Site Details: Vine House, Hampstead Square, London, NW3 1 AB

Title: GOS_VHHS_AIA_001_ADD

Published Date: 18th December 2019

I have been instructed to provide an Addendum to the originally published Arboricultural Impact Assessment (AIA) Report *Ref: (GOS_VHHS_AIA_001)*, following the addition of a new basement element to the original development proposal.

4.0 – East Side Garden – Tree Protection Plan

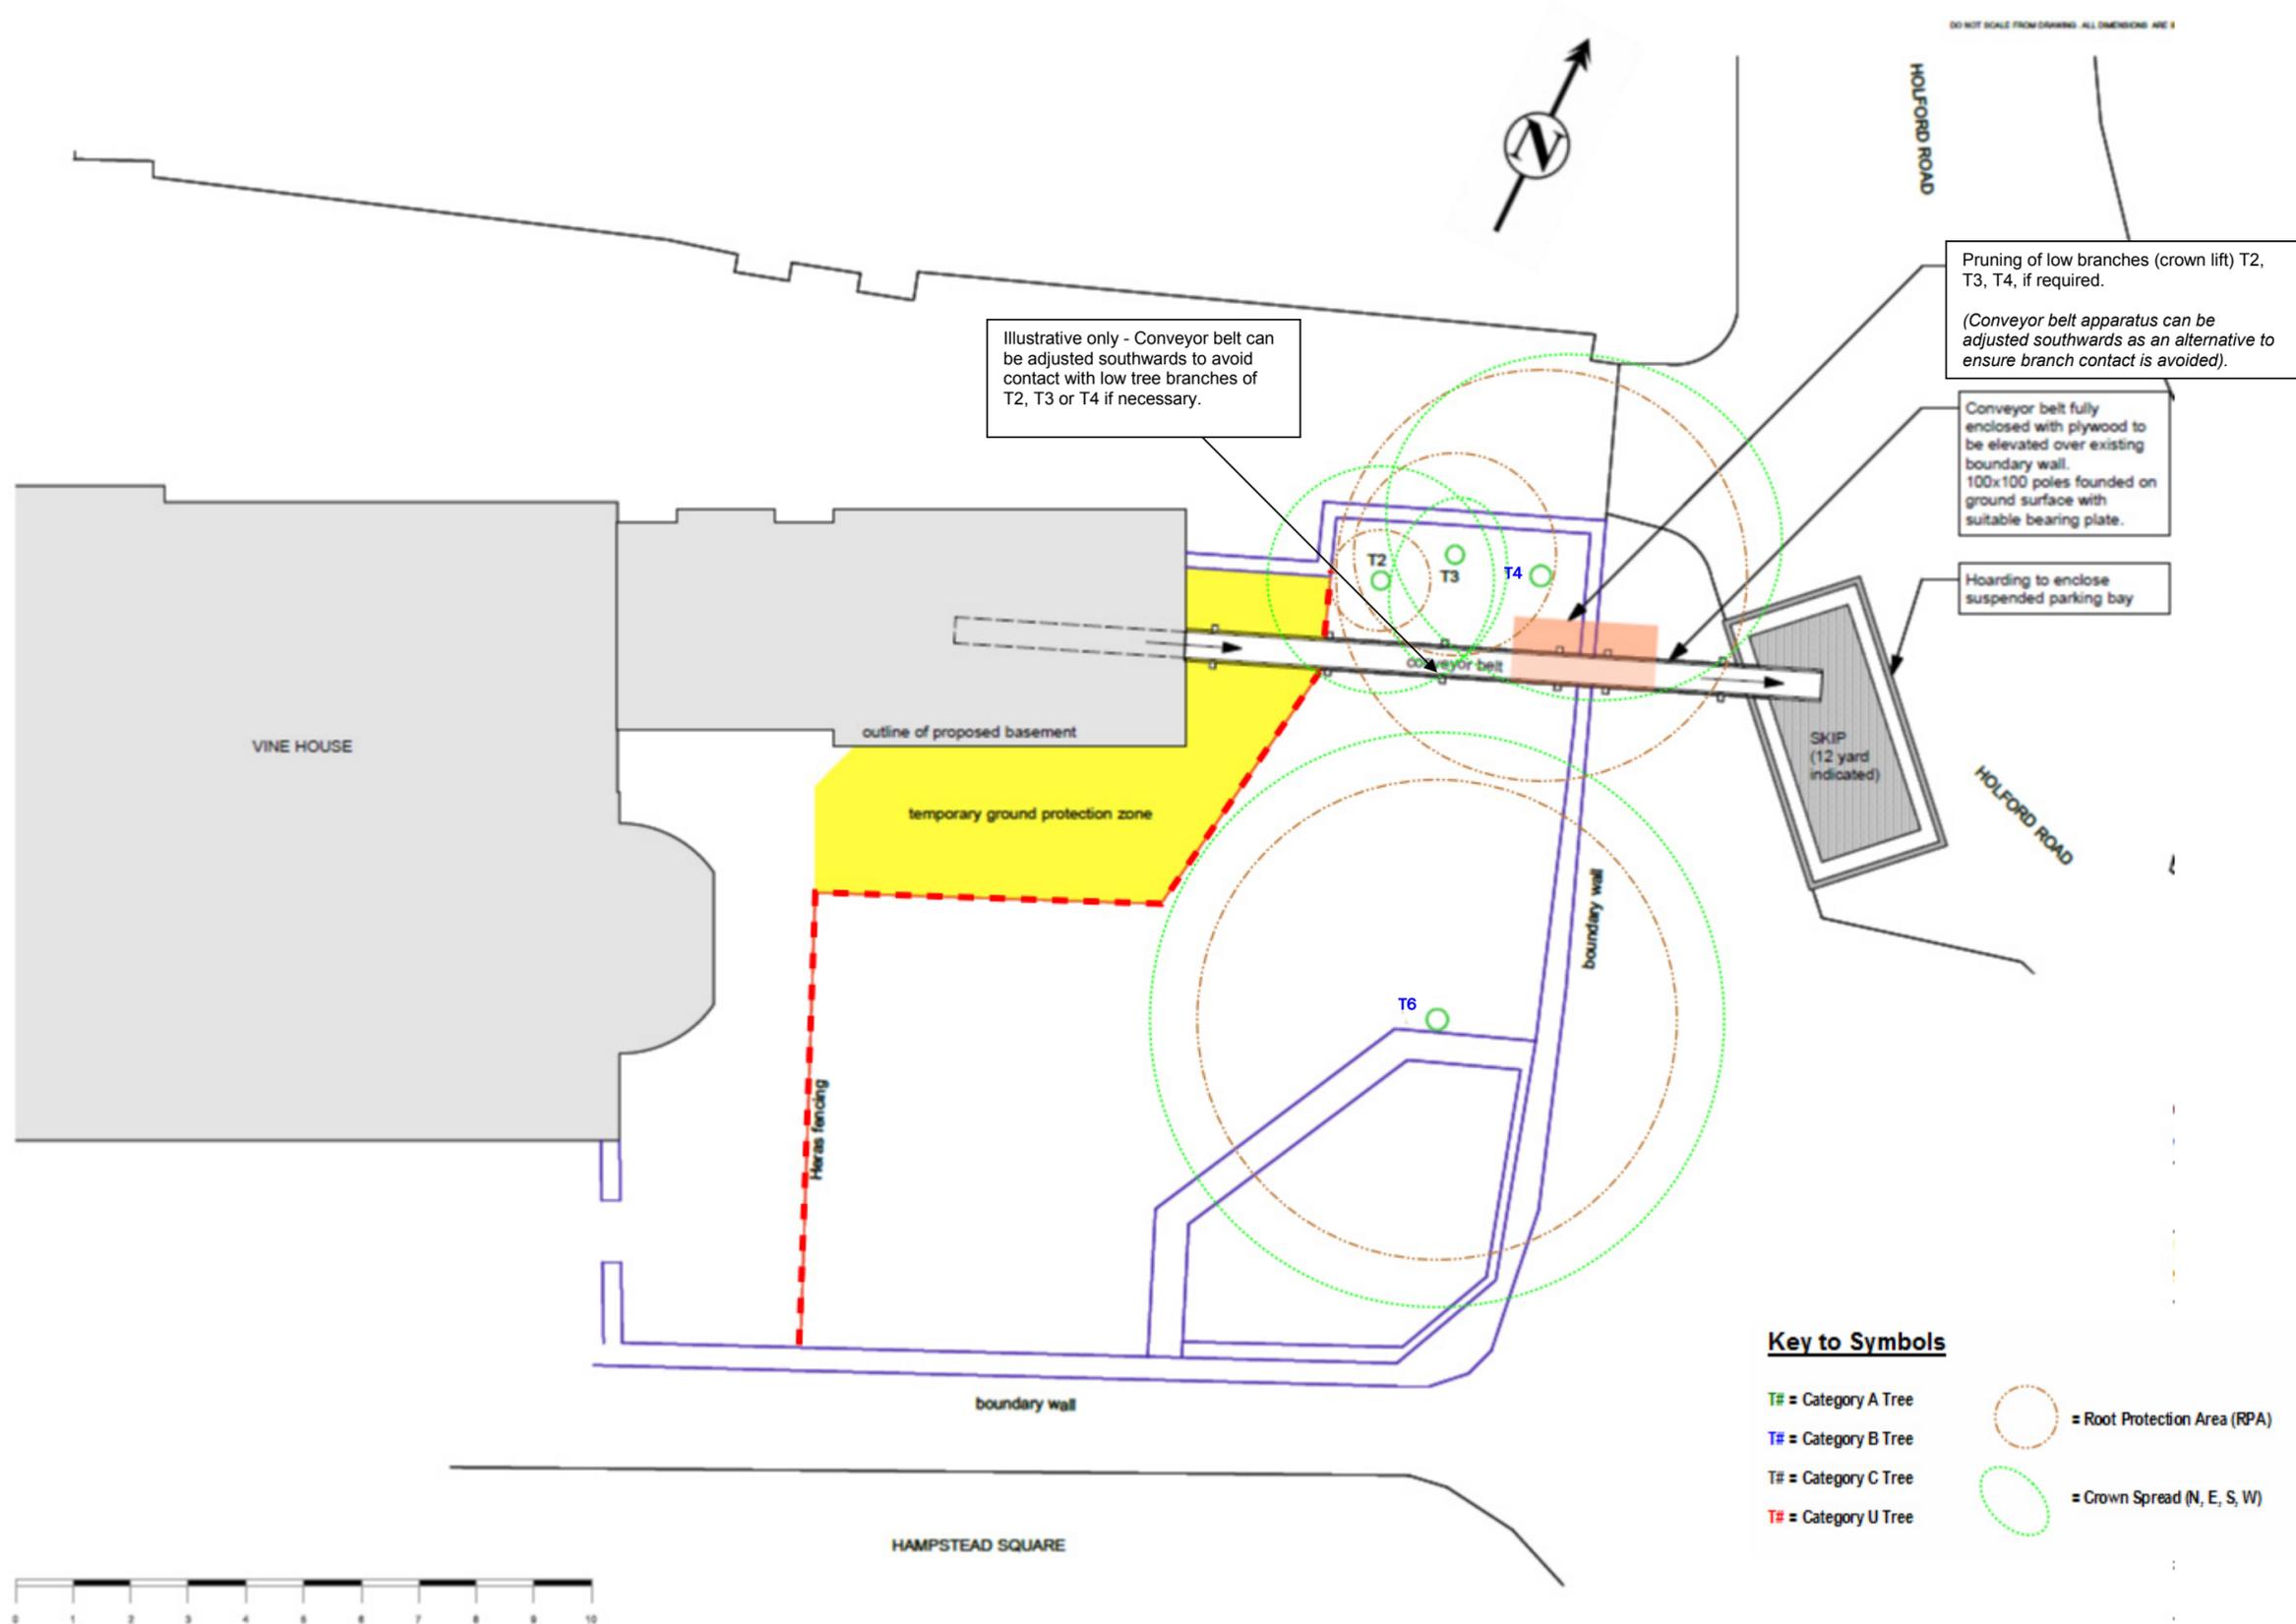
An access hole is to be cut into one of the Heras fence panels which is part of the Construction Exclusion Zone (CEZ 1) fence line in the East side garden. The conveyor belt can be constructed to pass through the hole in the fence panel and continue to extend over the East side boundary wall. The conveyor belt is to be fully enclosed with plywood and elevated over the East side boundary wall on supporting poles, which are to be installed on a load bearing ground plate at ground level.

The only amendment to CEZ 1 is the requirement to cut a hole in one of the Heras fence panels (which is easily achieved, being of steel mesh construction), to allow for the conveyor belt apparatus to be constructed and pass through the CEZ fencing.

An additional ground plate is to be laid inside the CEZ 1 fence line, required as a base for the conveyor belt support poles, as this will be inside the calculated RPA for T4. (See Section 4.0 below).

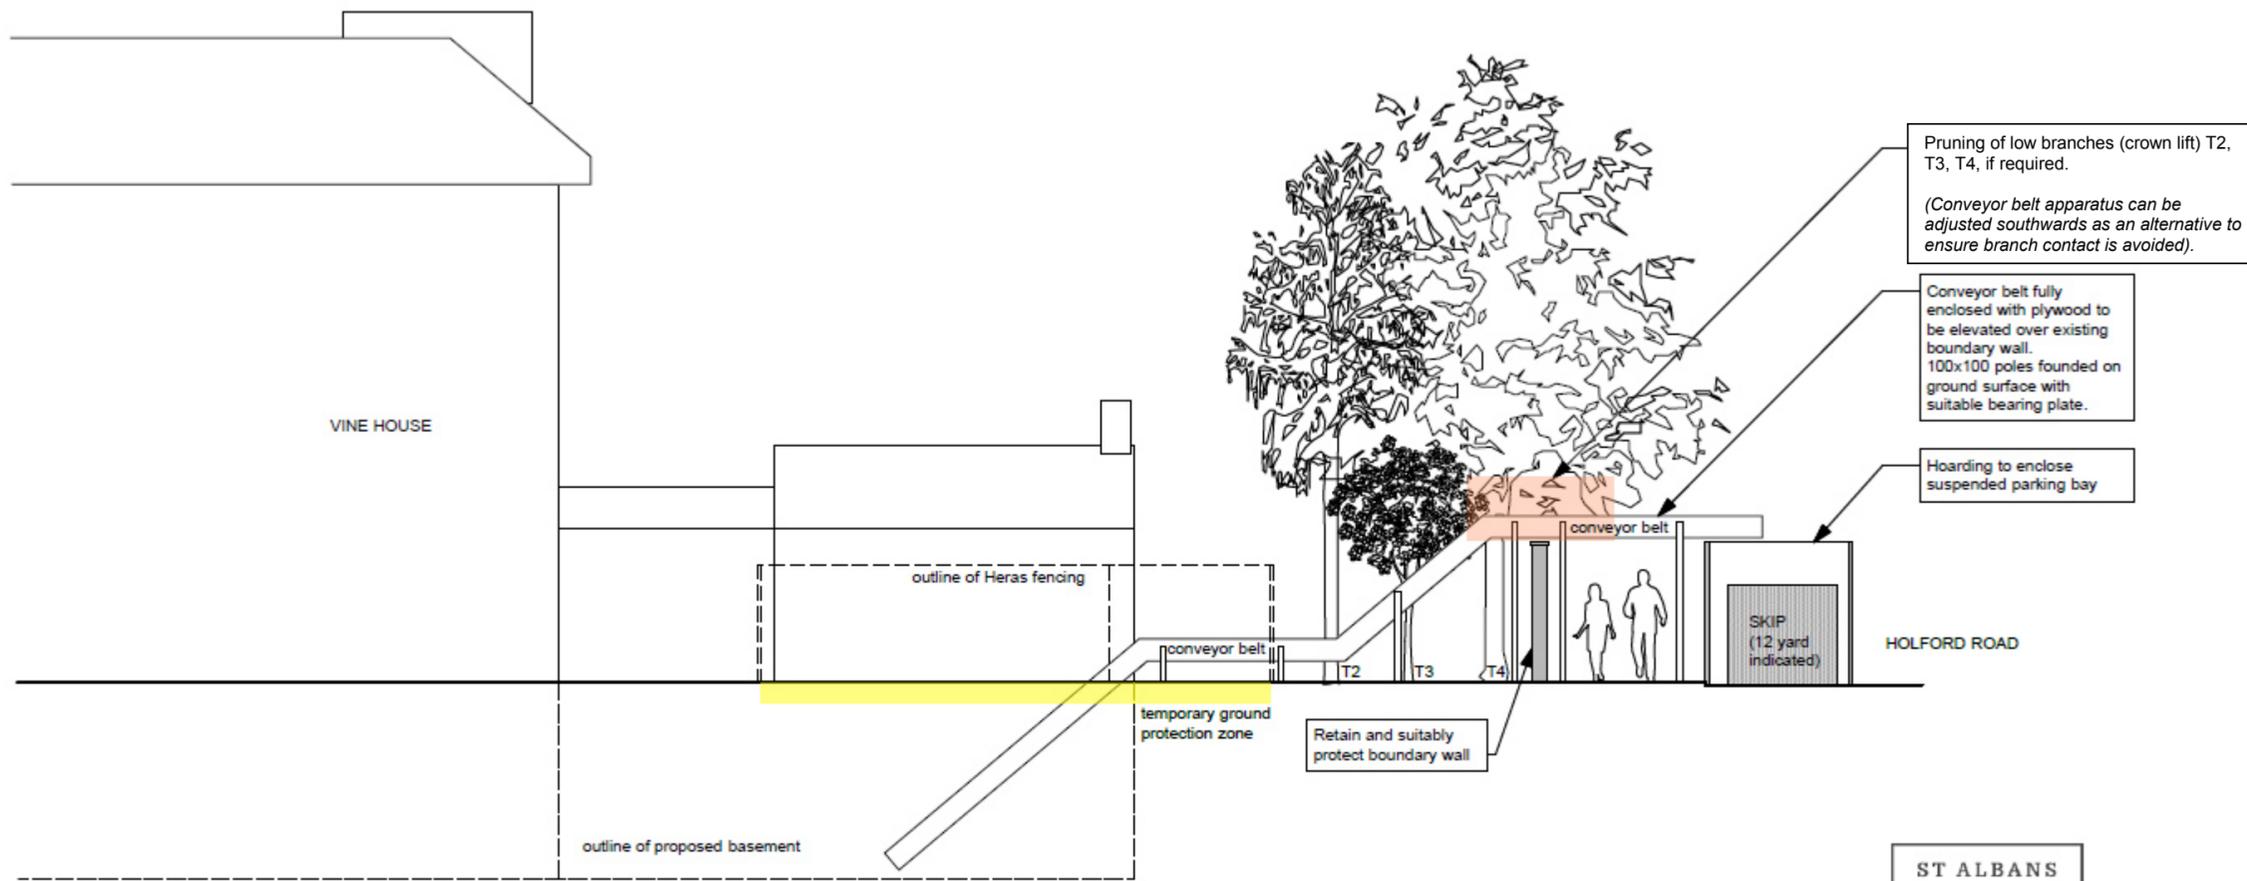
Since the removal of T5, there is adequate space for the conveyor belt apparatus to be installed over the East boundary wall without causing impact on the crowns of T2, T3, T4 and T6 which remain. The eastern crown spreads of T2, T3, T4 and T6 do not extend beyond the kerb line on Holgate Road, therefore the grab lorry can operate to remove spoil from the skip without impact on the trees branches. As an additional precaution, timber guide poles can be installed on the backside of the skip and operations to empty the skip must be supervised by a groundsman during operation of the grab boom.
